SUBJECT: PUD-72

PURPOSE: Application for Planned Unit Development rezoning of two parcels totaling approximately .51-acres from the RM-1,500 (Multiple-Family Residential) District to the PUD-HDR (Planned Unit Development – High Density Residential) District and development plan approval to construct three new residences.

LOCATION: 4693 and 4715 Augustine Street

Site Plan

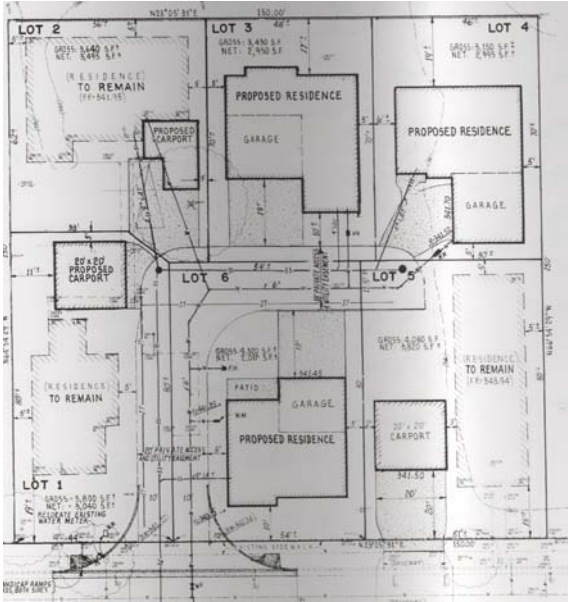
As conditions of approval, the private access entry would be modified to reduce the radii to reflect a more typical residential driveway apron design and requires a maintenance agreement for the private drive to be created.
